Access Compliance Report

Public Rights-of-Way

(Pedestrian Signals)

Intersection ID: N/A	Main Street:	Cross Street: N/A	Location: N/A
ADA ID: 21F10E7EC0B2	Signal Type: One Push Button-Non APS	Overall Compliance: No	Severity Score: BTN 1: N/A BTN 2: N/A No BTN: N/A
Codes/Mitigation Info/Possible Solution		Field Measurements/Component Compliance

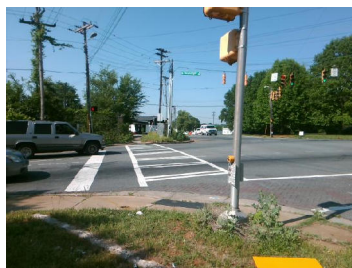
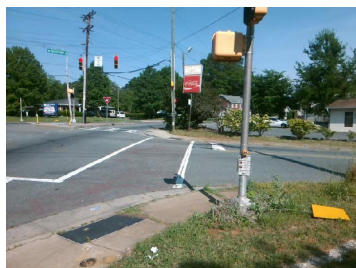
PROW/ADA: R404.2, R404.3, R404.7.3, R404.7.2

N/A	B 1 FWD Approach Width (in)	N/A	N/A	B 2 FWD Approach Width (in)	N/A
N/A	B 1 FWD Approach Obstruction?	Yes	N/A	B 2 FWD Approach Obstruction?	N/A
N/A	B 1 FWD Approach Obstruction Dist (in)	6.0	N/A	B 2 FWD Approach ObstructionDist (in)	N/A
N/A	B 1 PARA Approach?	Yes	N/A	B 2 PARA Approach?	N/A
N/A	B 1 PARA Approach Constrained?	Yes	N/A	B 2 PARA Approach Constrained?	N/A
No	B 1 PARA Approach Reach (in)	14.0	N/A	B 2 PARA Approach Reach (in)	N/A
No	B 1 PARA Approach Width (in)	48.0	N/A	B 2 PARA Approach Width (in)	N/A
N/A	B 1 PARA Approach Obstruction?	Yes	N/A	B 2 PARA Approach Obstruction?	N/A
N/A	B 1 PARA Approach Obstruction Dist (in)	6.0	N/A	B 2 PARA Approach ObstructionDist (in)	N/A
No	B 1 Clear Floor Space Slope (%)	4.1	N/A	B 2 Clear Floor Space Slope (%)	N/A
No	B 1 Clear Floor Space XSlope (%)	5.1	N/A	B 2 Clear Floor Space XSlope (%)	N/A
N/A	B 1 PAR Slope (%)	3.7	N/A	B 2 PAR Slope (%)	N/A
Yes	B 1 Height (in)	40.0	N/A	B 2 Height (in)	N/A

Possible Solutions: Remove and Replace Clear Space.
